# Access Compliance Report

## Public Rights-of-Way

Intersection ID: 53215	Main Street: BUICK_DR	Cross Street: CONFERENCE_DR	Location: NE
ADA ID: 648E270A05B7	Ramp Type: PerpDiag	Initial Pass/Fail: Fail	Overall Compliance: No
Severity Score: 13.75			
Codes/Mitigation Info/Possible Solution		Field Measurements/Component Compliance

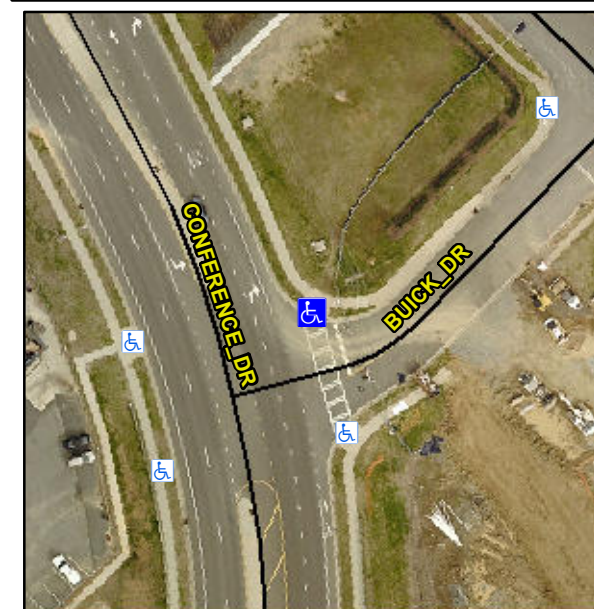
**R304.2.2, R304.5.3**

Compliance	Description	Data	Compliance	Description	Data
N/A	Ramp Length (in)	67.0	No	Ramp Slope (%)	8.8
Yes	Ramp Width (in)	48.0	No	Ramp XSlope (%)	2.9
N/A	Flare Type LT	N/A	N/A	Flare Type RT	N/A
N/A	Flare Slope LT (%)	N/A	N/A	Flare Slope RT (%)	N/A
N/A	Flare Traversable LT?	N/A	N/A	Flare Traversable RT?	N/A
N/A	Landing Length (in)	N/A	N/A	DWS Provided?	N/A
N/A	Landing Width (in)	N/A	N/A	DWS Contrast?	N/A
N/A	Landing Slope (%)	N/A	N/A	DWS Length (in)	N/A
N/A	Landing X Slope (%)	N/A	N/A	DWS Full Width?	N/A
N/A	Landing Curb? (Y/N)	N/A	N/A	DWS Offset (in)	N/A
N/A	Shared Landing?	N/A			
N/A	Gutter Ponding?	N/A	N/A	Gutter Slope (%)	N/A
N/A	Gutter Lip Ht (in)	N/A	N/A	Gutter X Slope (%)	N/A
N/A	Painted X Walk1?	No	N/A	Painted X Walk2?	Yes
	X Walk 1 Direction	To W		X Walk 2 Direction	To S
N/A	X Walk 1 Width (in)	N/A	N/A	X Walk 2 Width (in)	112.0
	X Walk 1 Slope (%)	2.1		X Walk 2 Slope (%)	1.6
	X Walk 1 X Slope (%)	0.7		X Walk 2 X Slope (%)	1.5

**Remove & Replace Curb Ramp With Two New Directional Ramps or Equivalent.**
